## Point by Point Response to RC1

**This article discusses a new method for correcting spectral nonlinearity of GIIRS on Fengyun-4 satellite and its preliminary evaluation, to overcome the inaccurate linear coefficient which is inevitably affected by NL response of sensor and impacted on the NL correction, an iteration algorithm is established to make both the linear and the NL coefficients to be converged to their stable values with the relative errors less than 0.5% and 1% respectively, which is universally suitable for NL correction of both infrared and microwave sensors.**

In general, all the authors of this manuscript shall show their appreciations to the community comments from Dr. Gerald Turner (CC2) on amt-2023-242, some (i.e. Comment 01 and Comment 09) of which do help us to improve our paper. Here, point-by-point responses to these comments are provided as follows:

Figure 2. The simple schematic diagram of Michelson interferometer.

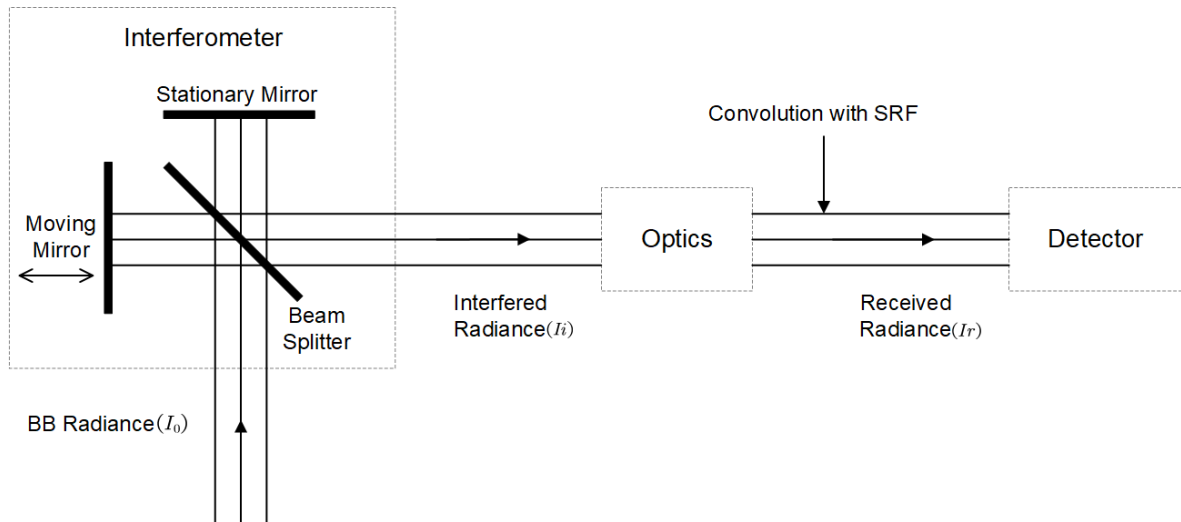
**Comment 03:** In figure 2, three labelled information in parallelograms need to be given in a more accurate manner. For example, these parallelograms may be deleted directly.

**Comment 21:** In Figure 2, the BB radiance has been modulated as an interferogram in temporal space, rather than a spectrum, and therefore cannot be convolved with SRF in frequency space. The signal received by the detector is interferogram rather than radiance.

**Response 03:** This comment is helpful and has been adopted by the authors. Modifications have been made in Figure 2 of the original manuscript. Please refer to lines 120-123 in section 2.2.1 of the revised manuscript.

**Response 21:** Again, the authors claim that the interferogram of a FTS (i.e. GIIRS) is essentially the interfered radiance with different optical path differences from target, the unit of which is same as that of traditional radiance. Once the corresponding optical path difference and phase error are known, the interfered radiance can be calculated accurately. In our study, the interfered radiance (or called interferogram) at absolute ZPD (namely without influence of phase error) is utilized for radiometric calibration together with NL correction within the whole responsive band (i.e. LWIR) of a FTS, not merely for a single channel after Fourier transform.

(a)  $\Delta BT$  after NL correction for 56<sup>th</sup> detector

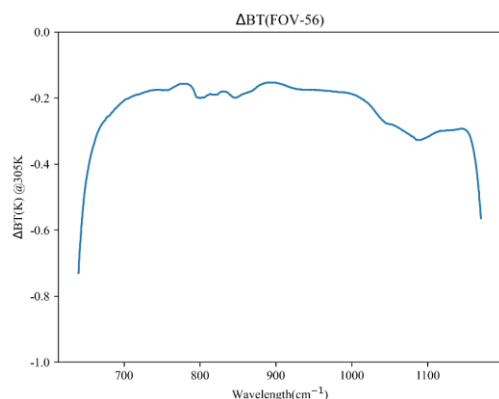
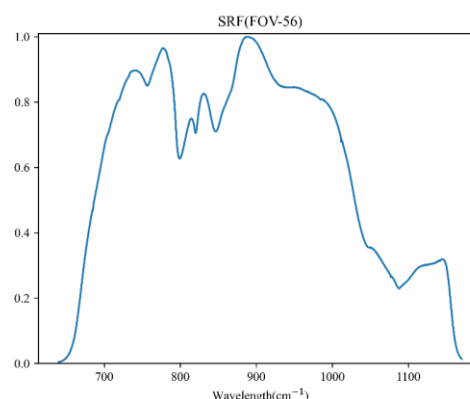
**Comment 35:** From Figure 11 it can be confidently confirmed that the radiometric calibration failed, let alone the non-linear correction. According to pre-launch radiometric calibration tests such as IASI and CrIS, the BT deviation of the blackbody calibrated spectra should not have significant spectral characteristics, and its mean value should be a straight line trend along the spectral abscissa. In Figure 11, The BT deviation still remains the characteristics of the instrument's spectral responsivity. It means that the calibration does not eliminate the instrument effects, thereby defeating the purpose of radiometric calibration.

**Response 35:** The comment is irresponsible from a technical perspective or maybe Dr. Gerald Turner (CC2) does know little about radiometric calibration of an infrared sensor. As shown in equation 1, the outcomes (DN) of a sensor will be calibrated according to the incident radiance which should be known ahead of time. Here, the physical quantity to be calibrated is radiance rather than BT. Thus, in this sentence of “its mean value should be a straight line trend along the spectral abscissa” given by CC2, the mean value should be referred to radiance instead of BT, while both  $\Delta\text{BT}$  and delta radiance are not proportional within infrared spectral range. Meanwhile, the influence of NL upon smaller incident

radiance (i.e. measurements at the marginal position of SRF for a FTS) is much more than those of bigger ones (i.e. those near the central position of the whole spectral band). Here, the  $\Delta BT$  after NL correction and its SRF of 56<sup>th</sup> detector of FY-4B/GIIRS are shown for comparison as in the following figures (a) and (b), respectively. Clearly, the characteristics of detector's SRF is almost eliminated particularly for main spectral region (i.e. 700-1000 $\text{cm}^{-1}$ ). Therefore, the results of figure 11 are relative reasonable doubtlessly.
